S J Bialecki Limited Building Surveyors
Drawing no 5003/a/b
Scale 1:50
Proposed Elevations
Proposed New Classroom And Dormitory Extension Moorland School Clitheroe

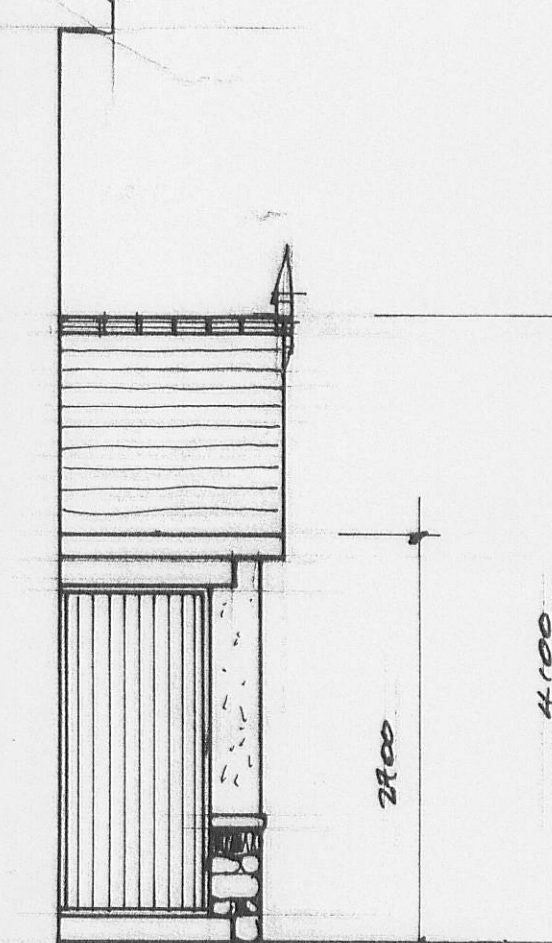
AMENDMENTS JUN/02
INCREASE ROOF PITCH
FROM 30° TO 35° TO
ALLOW MEZANINE FLOOR.

AMENDMENTS JAN/02
MOVING TO EXTERIOR
FIRE ESCAPE
